# MODIFICATION LINCOLN II

## SSB/S meter/RX Audio

LINCOLN II components side

**PART 1**

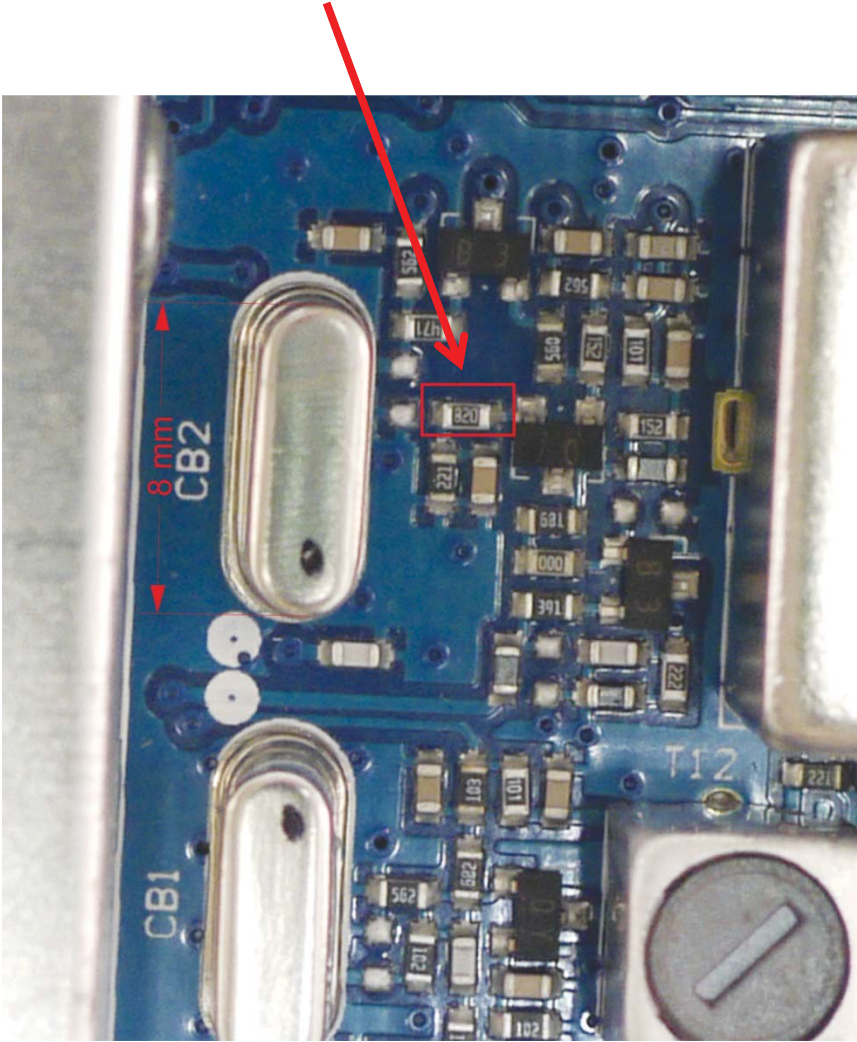
Replace R122 from 82Ω to 150Ω

**PART 2**

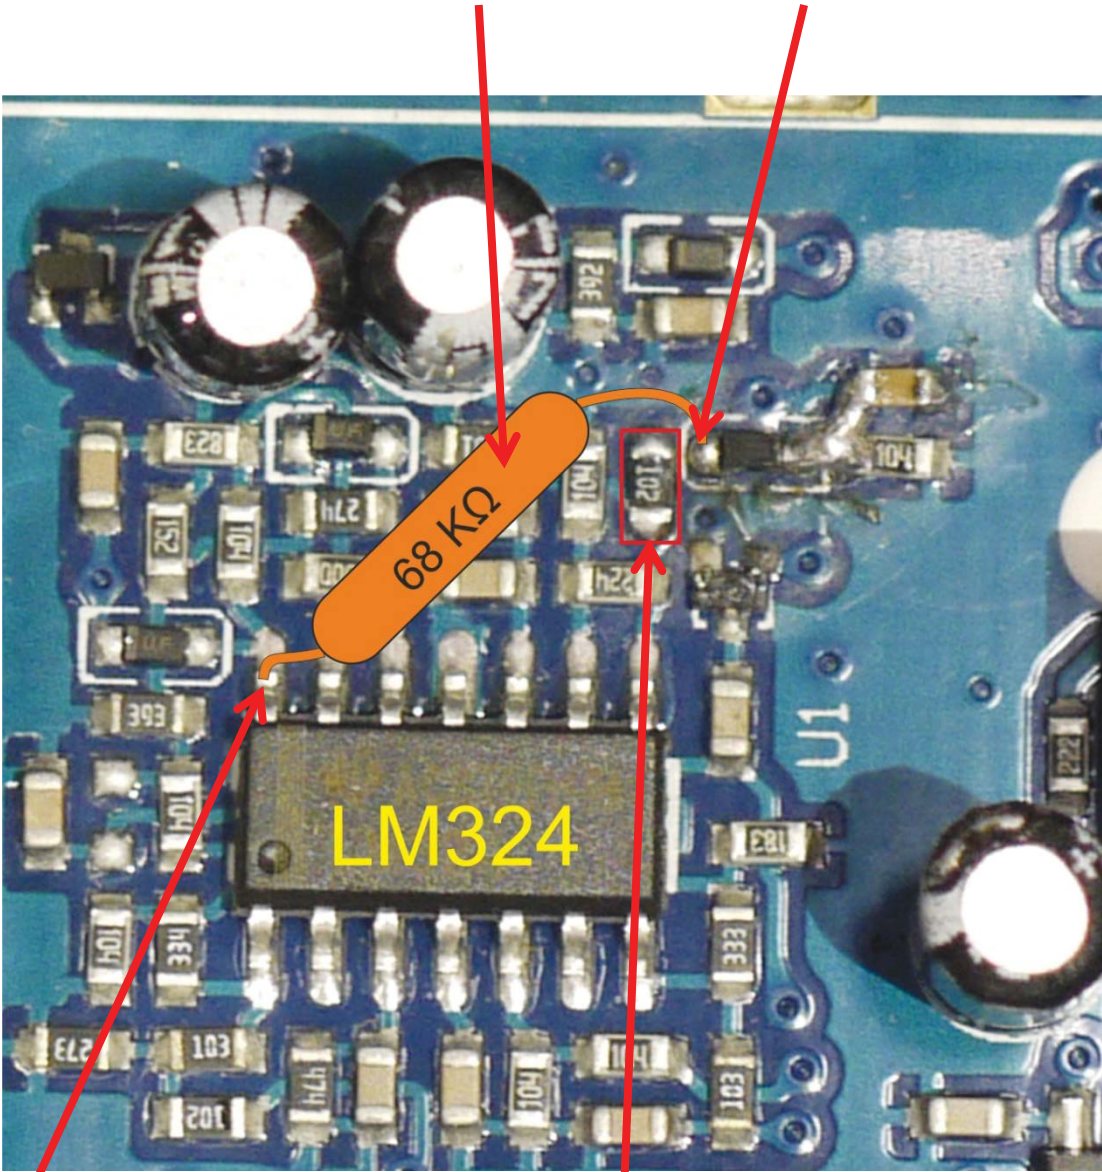
Solder a resistor of 68KΩ between U1D pin 14 and the anode of D40

U1D pin 14

Delete R252

**PART 3**

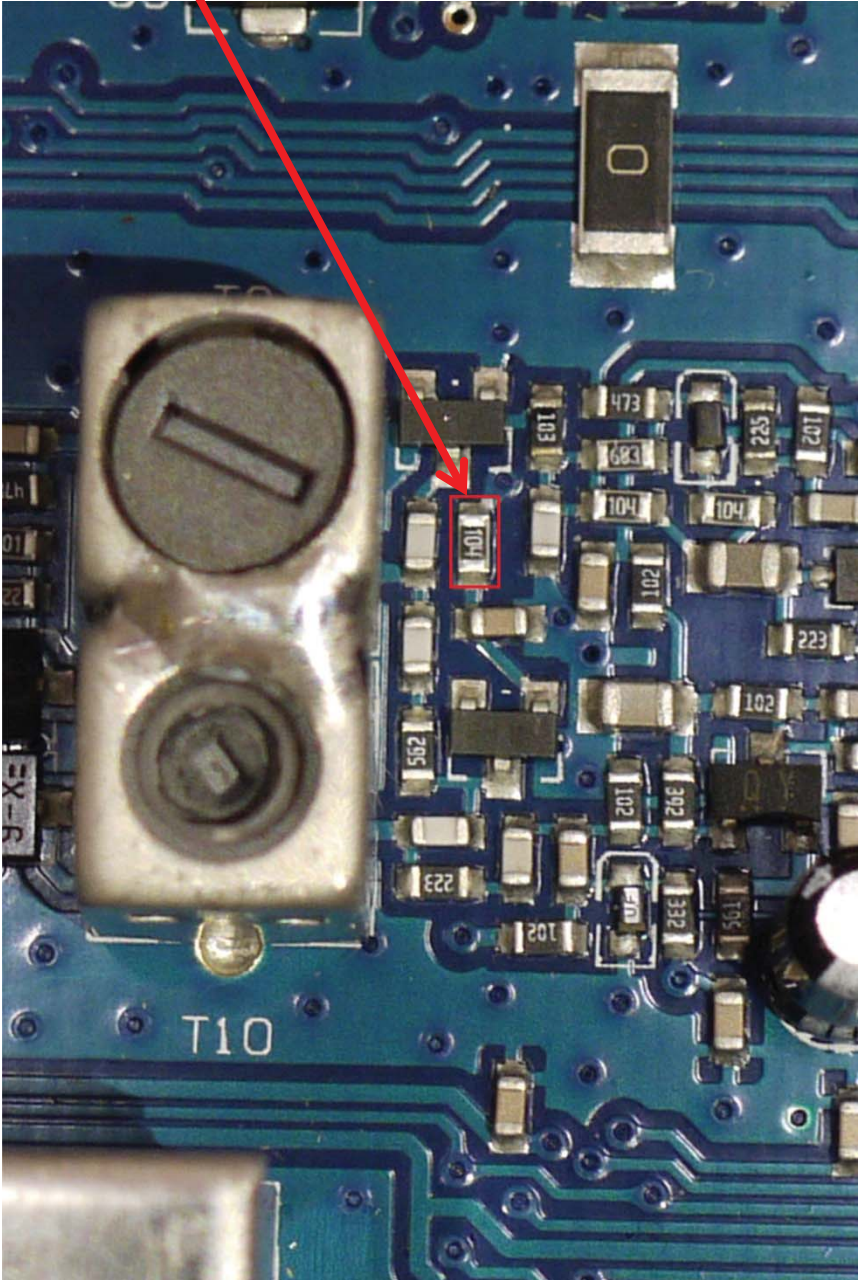
Delete R205 100KΩ and solder a strap

Replace C136 from 10nF to 0,1μF

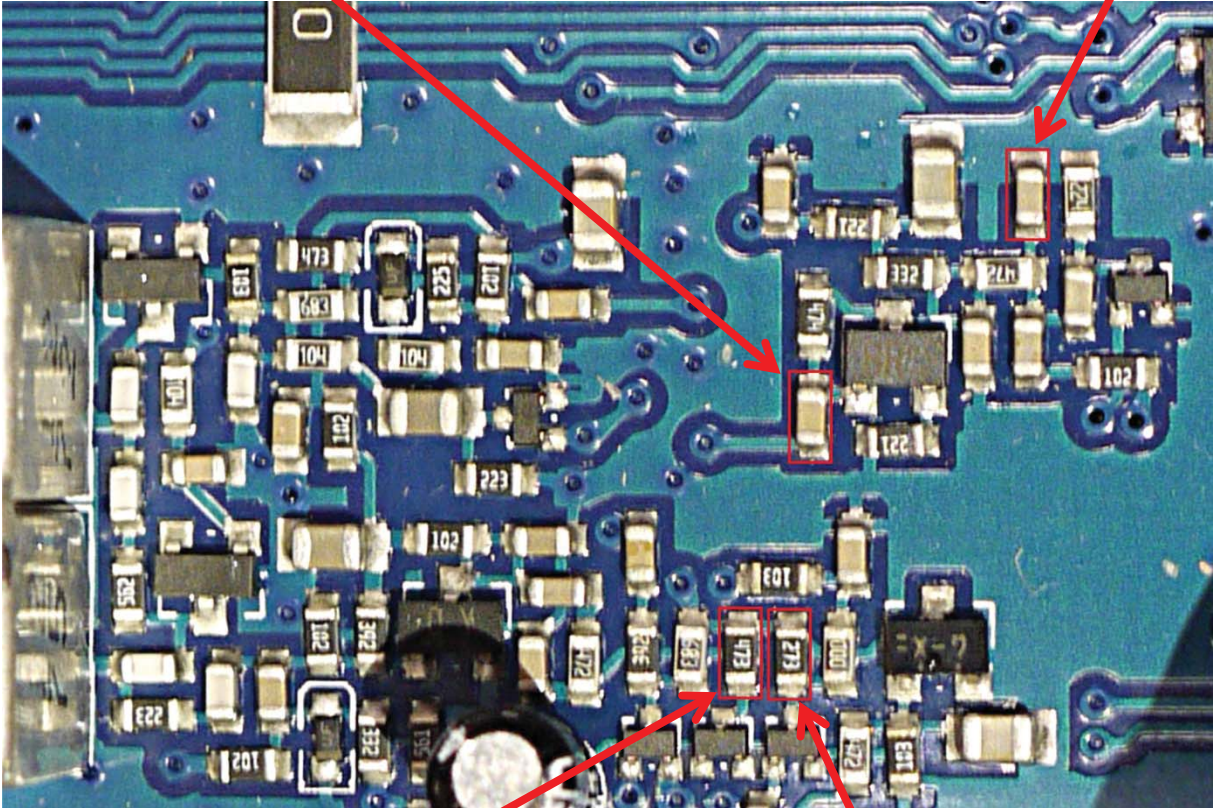
Delete C262

Replace R179 from 47KΩ to 22KΩ

Replace R206 from 27KΩ to 10KΩ
